**RE: 2 Rapere Street: No Argon Gas in double glazed glasses**

# HAGLEY JOB SETOUT SHEET

SITE ADDRESS: **2 PAVARA STREET, DELISTON**

JOB NO **27363**

Entry

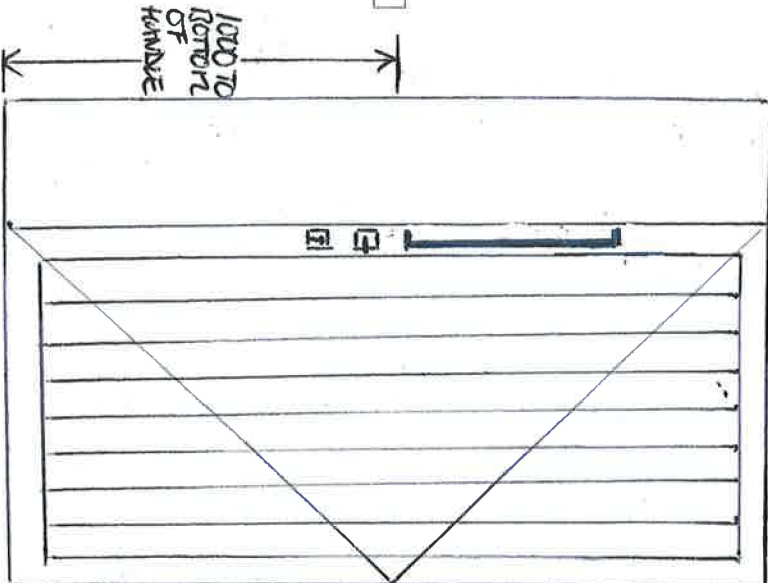
I have noted on the order sheet to remove ARGON GAS from the paperwork and to change the Entry Door Panel to have the Dark Cedar Woodgrain finish to the outside of the Panel with Mannex Coal Dust colour to the inside.

We have also changed the Entry Door Handle as we discussed yesterday. Please see Detail attached.

Panel Colour inside: **MUNITEK CORR DUST**

Panel Colour outside: **DARK CEDAR WOOD GRAIN**

Handle Type: **WINDSOR 1130 600 - NITRO PUL HANDLE (BLACK)**

Height to Handle: **800** } **WILL HANDLE TO BE POSITIVE AS DETAIL**

\* MUNITEK CORR DUST INSIDE OF PANEL.

\* DARK CEDAR WOOD GRAIN OUTSIDE OF PANEL.
